Planning Commission Draft Motion

Hearing Date: November 10, 2011
Case No.: **2005.1004E**
Project Address: **Glen Park Community Plan Area**
Zoning: Various
Block/Lot: Various
Project Sponsor: San Francisco Planning Department
1650 Mission Street, Suite 400
San Francisco, CA 94103

TO: Members of the Planning Commission and Interested Parties
FROM: Bill Wycko, Environmental Review Officer
RE: **Attached Comments and Responses on Draft Environmental Impact Report, Case No. 2005.1004E Glen Park Community Plan Project**

Glen Park Community Plan

GLEN PARK COMMUNITY PLAN
FIGURE C&R-6 (REVISED FIGURE II-2): EXISTING USE DISTRICTS AND HEIGHT LIMITS

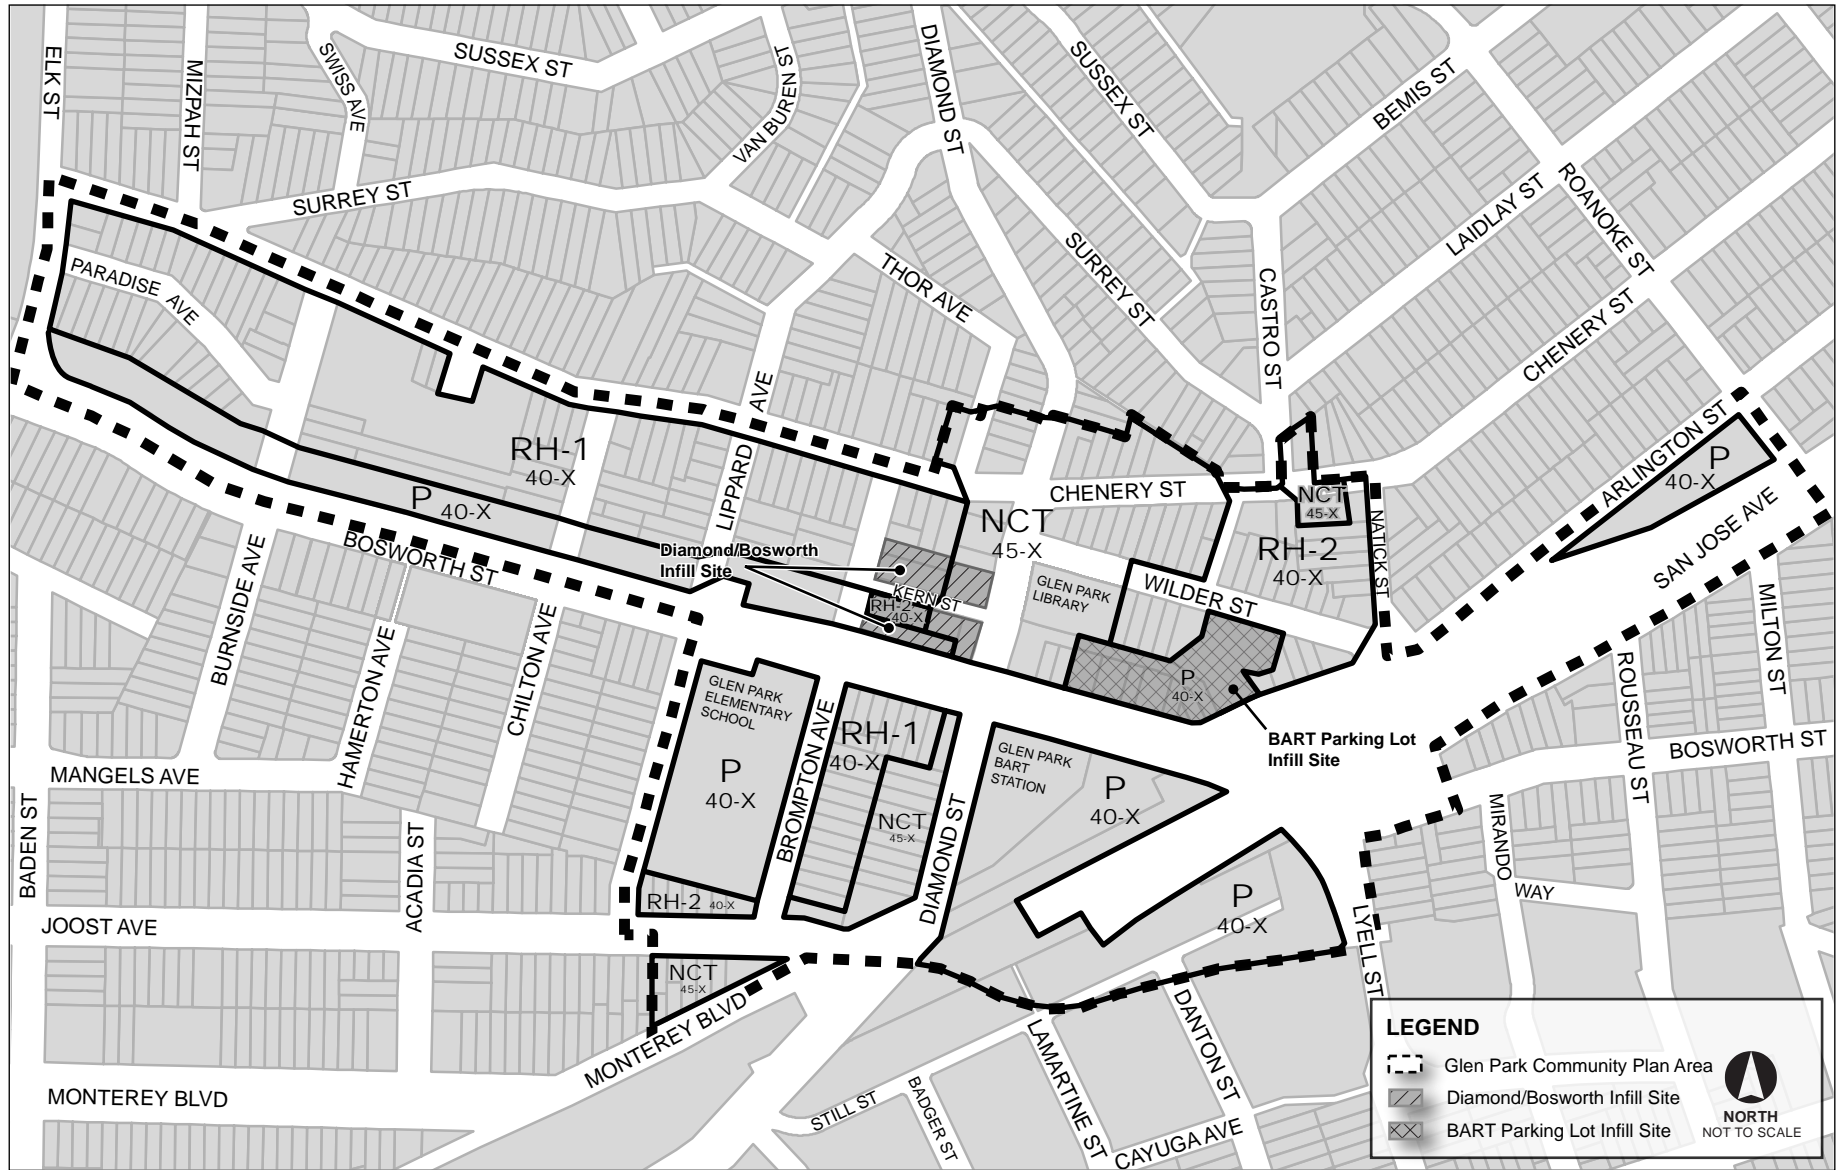
Nine figures have been revised to update the plan area boundary to include 3121-3125 Castro Street and the fronting street and intersection. These figures include:

- Figure II-1, p. II-7, Regional and City Project Location
- Figure II-2, p. II-10, Existing Use Districts and Height Limits
- Figure II-3, p. II-14, Use Districts and Height Limits Under the Proposed Project
- Figure II-4, p. II-23, Transportation Improvement Locations
- Figure III.B-1, p. III.B-16, Cumulative Projects for Glen Park Community Plan
- Figure III.D-1, p. III.D-13, Existing Historical Resources with the Plan Area
- Figure III.E-2, p. III.E-10, Existing Transit Network
- Figure III.E-3, p. III.E-19, Existing Bicycle Conditions
- Figure III.F-1, p. III.F-8, Noise Monitoring Locations

GLEN PARK COMMUNITY PLAN
FIGURE C&R-7 (REVISED FIGURE II-3): USE DISTRICTS AND HEIGHT LIMITS UNDER THE PROPOSED PROJECT

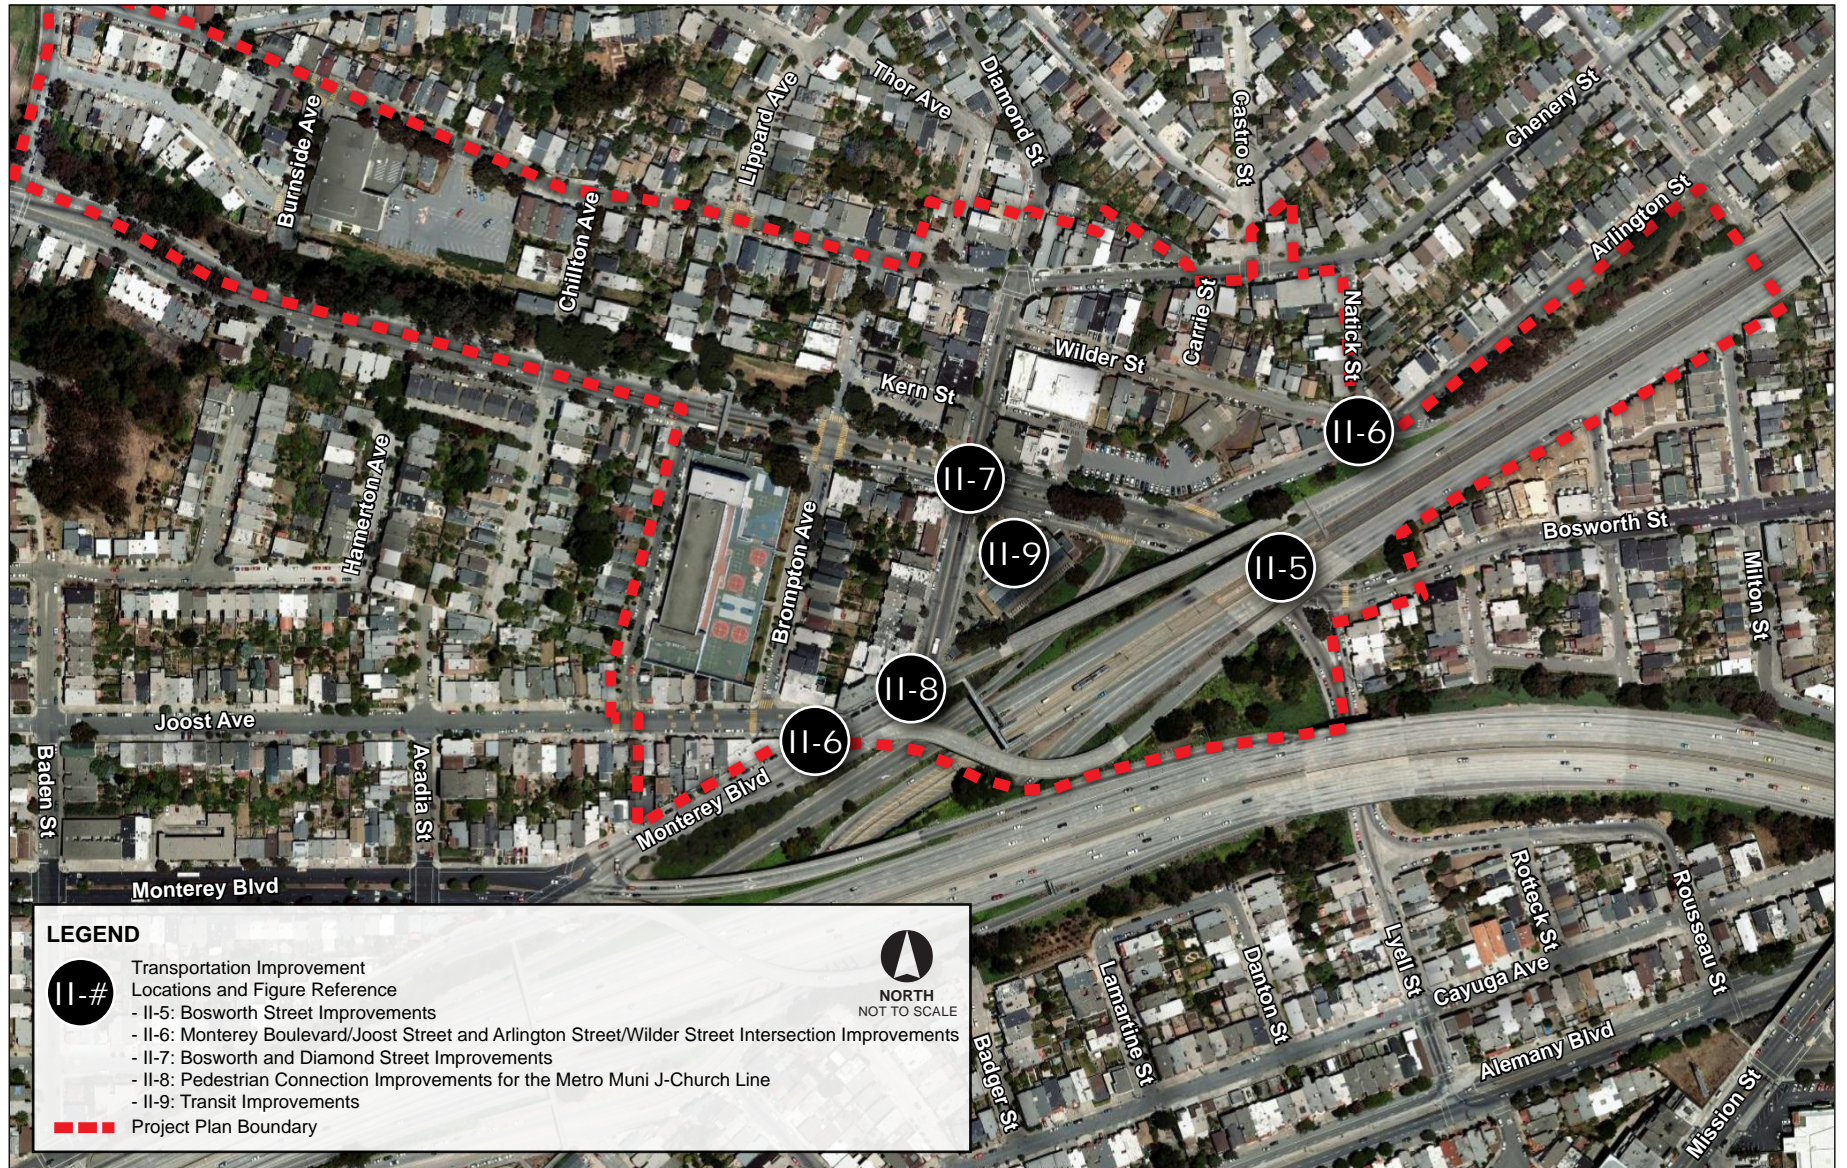
Infill Development. The *2010 Community Plan* contains policies recommending consideration of new development on two infill sites and development of 13 residential units, at-large in the plan area, and 5,250 gsf of ground-floor commercial uses near existing transit, and would not propose changes to established residential neighborhoods surrounding the plan area. Figure II-3, p. II-14, identifies the two infill sites in the plan area. The additional 13 residential units, at-large in the plan area, and 5,250 gsf of ground-floor commercial uses at 2928-2958 Diamond Street could be developed within the Glen Park NCT District; however, the exact location of ~~these~~ the 13 units is unknown at this time. Therefore, these units are not shown in Figure II-3, p. II-14.

GLEN PARK COMMUNITY PLAN
FIGURE C&R-10 (REVISED FIGURE III.D-1): EXISTING HISTORICAL RESOURCES WITHIN THE PLAN AREA

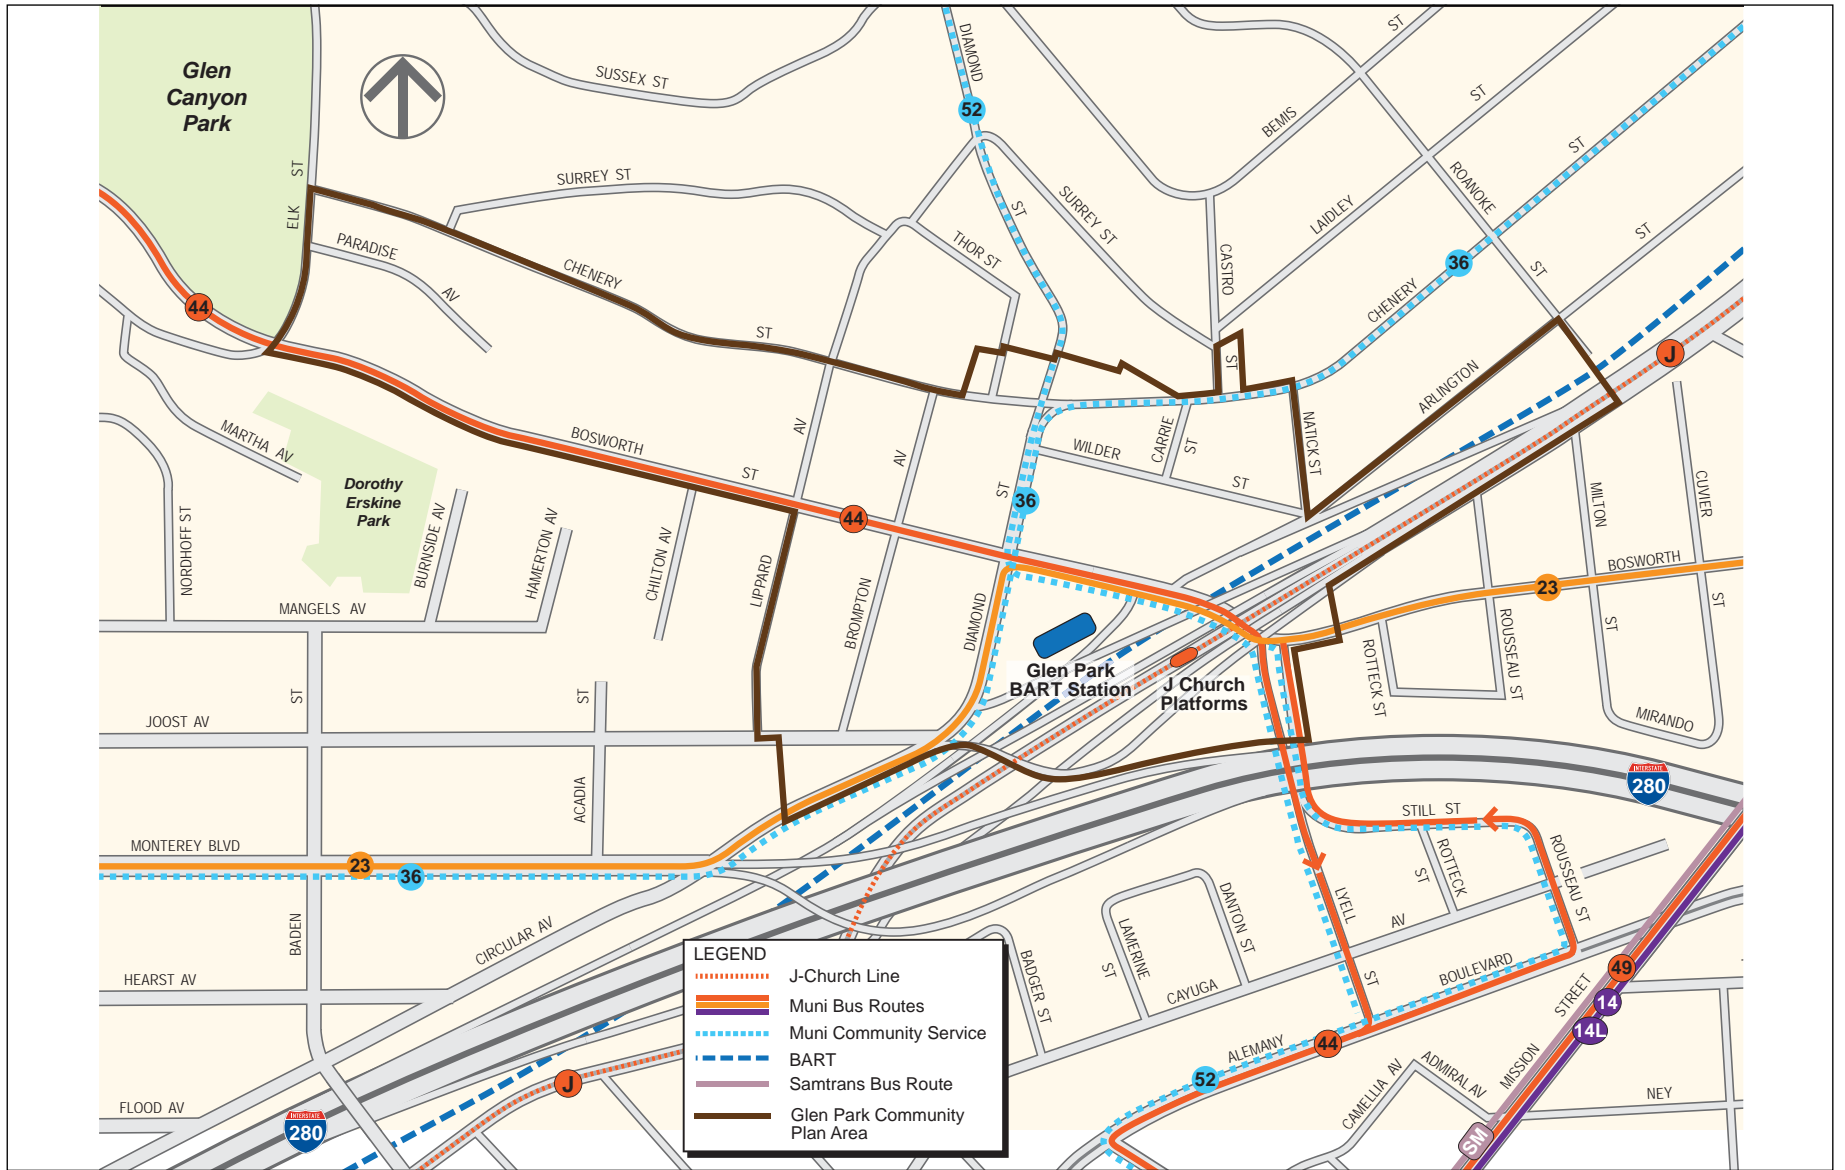
Revisions to Figure III.D-1, p. III.D-13, were also made to reflect that 3121-3125 Castro Street was surveyed by the Planning Department.

Height Limit objection

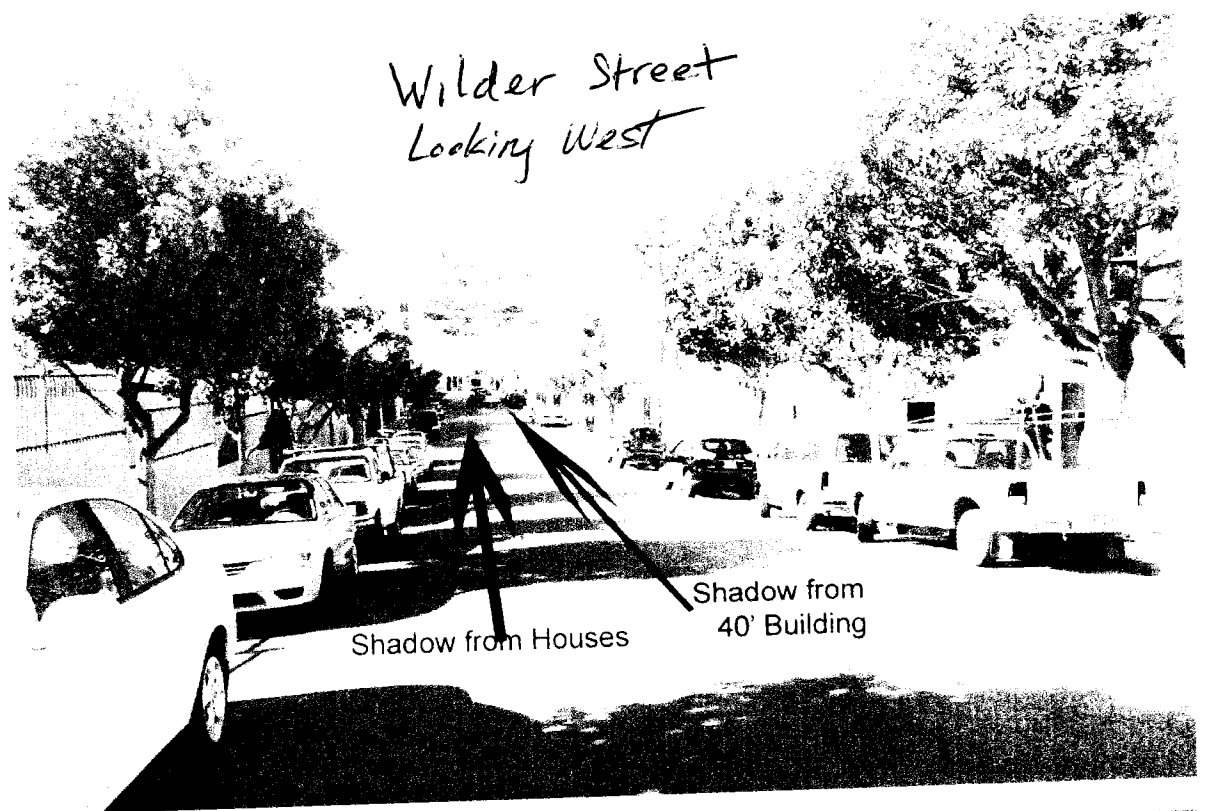
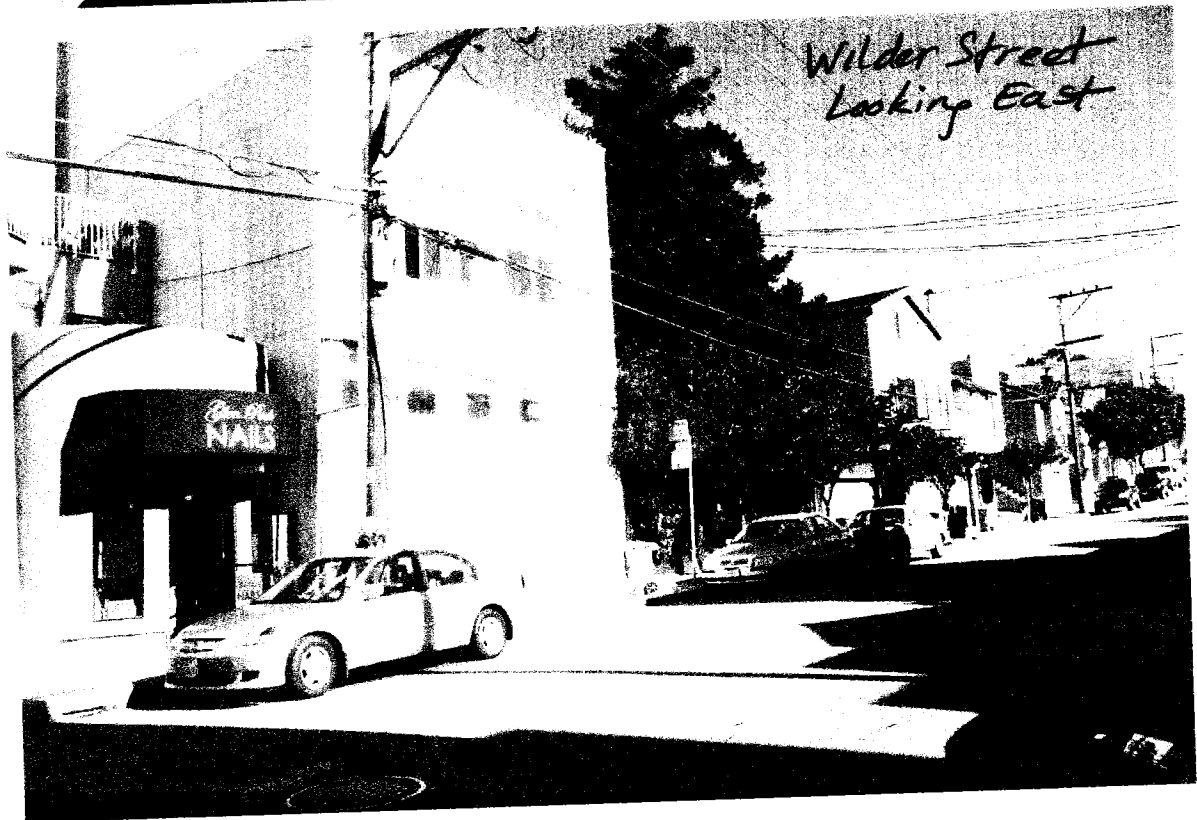
Example of the effect
of taller buildings
